TERRY CORPORATION

DESIGN IMPROVEMENT
DI 9

Because of damage occurring to the turbine governor valve stem gland air seal piping connection, prior to turbine installation, it is recommended that a support bracket be fabricated and installed to support piping connections in position as shown on the attached photograph.

FIG. 1
GLAND CONTAINMENT AND DRAIN PIPING SYSTEM REF DWG 89779C
SUPPORT BRACKET FOR TURBINE TRIP AND THROTTLE VALVE STEM
LOWER PRESSURE GLAND LEAK-OFF CONNECTION AND THE TURBINE
GOVERNOR VALVE PLUG STEM GLAND LEAK OFF

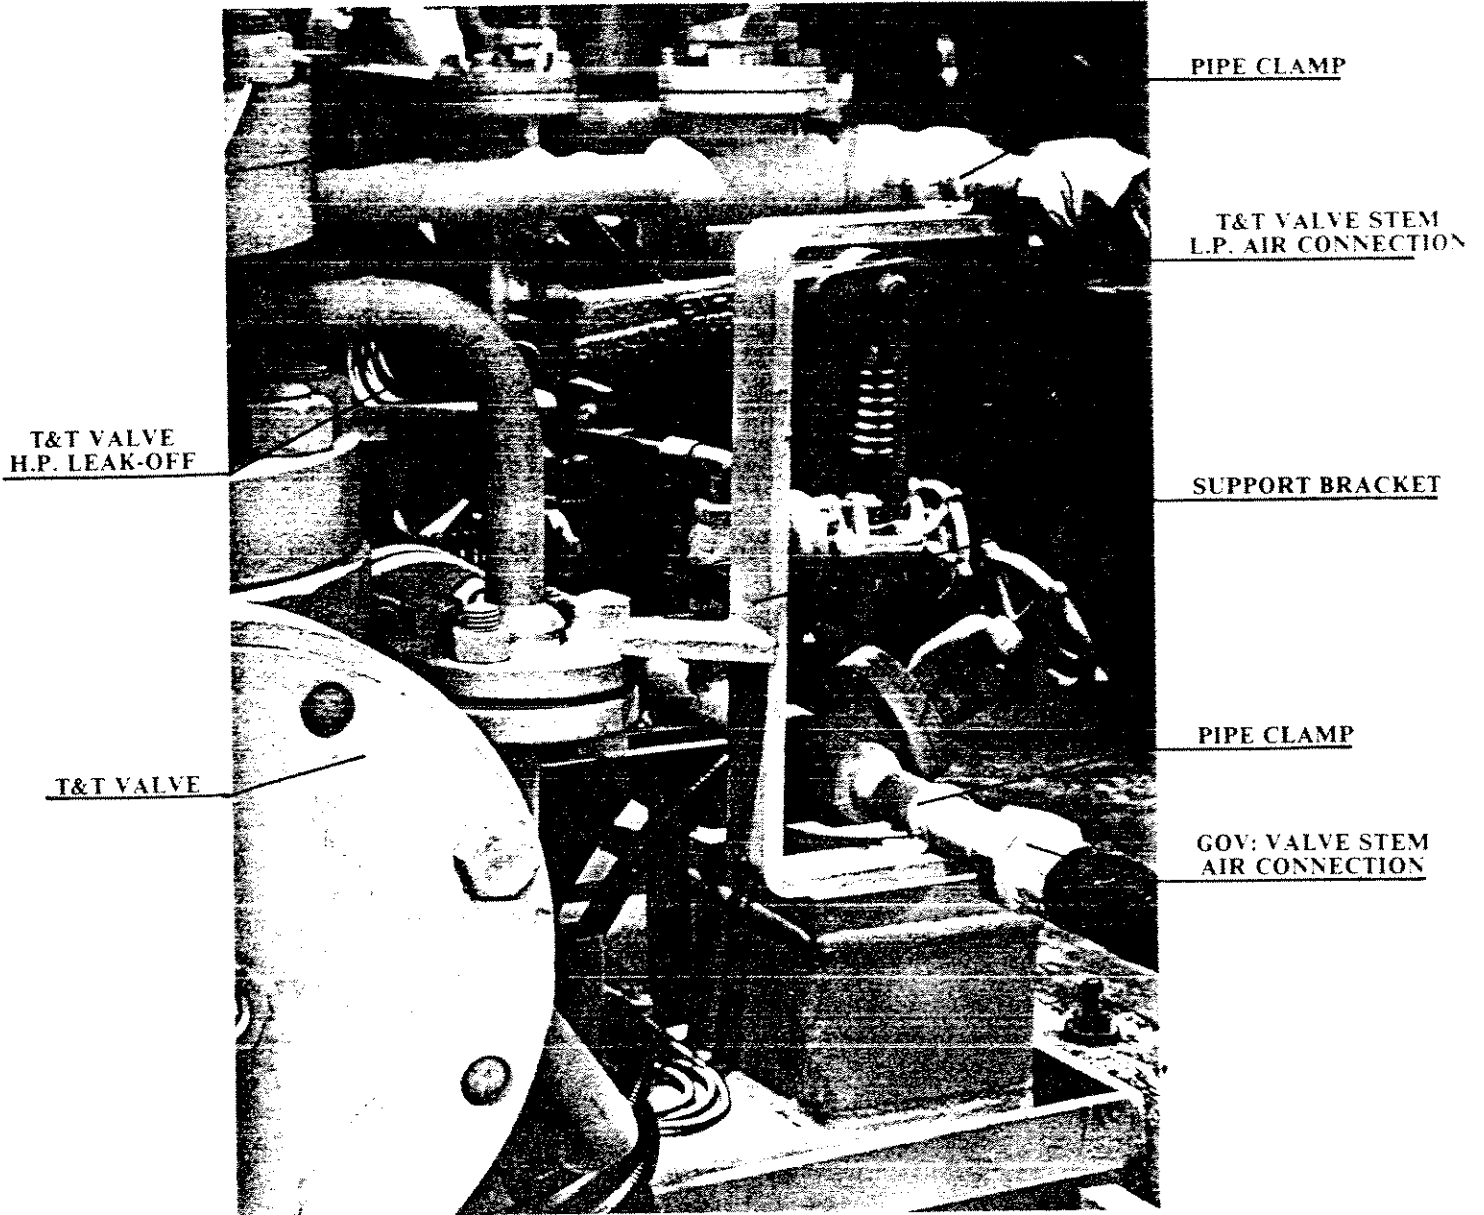
The support bracket is fabricated from flat bar stock (ASTM 108) 3/8 ins. thick by 2 ins. wide. The photo print shows the construction of the support and the use of pipe clamps to secure the piping connections.

Anchoring of the support bracket is achieved by bolting to the T&T valve stem high pressure leak-off piping flange.

The support bracket must be fabricated and installed to each individual turbine assembly because of minor variations in pipe routing.
